Date: January 13, 2020

Memorandum

Re: 19-35 River Street Comprehensive Permit - Stormwater, Drainage,
and Hydraulic Peer Review – 2nd Review

NOAA Atlas 14 IDF Curve for 19-35 River Street Winchester, MA

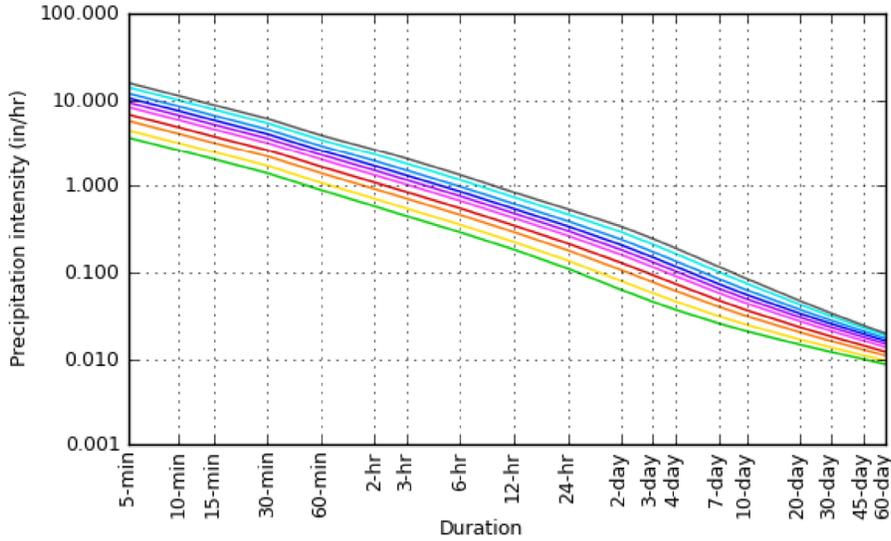
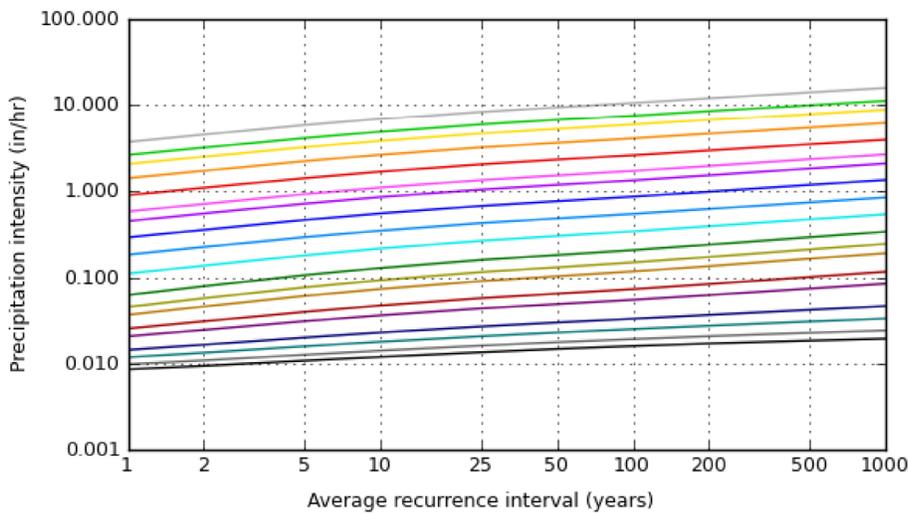
- a) **It appears that in the closed drainage analysis, the Applicant used the rainfall intensity from the Intensity-Duration-Frequency (IDF) curves in the MassDEP's 2002 Hydrology Handbook for Conservation Commissioners (or similar). These IDF curves are based on rainfall data that has since been superseded. Rainfall data from NOAA Atlas 14, Volume 10, Version 3.0 is currently considered the best available data and industry standard. Per NOAA Atlas 14, attached, the 5-minute rainfall intensity for the 25-year storm is 8.32 inches/hour.**
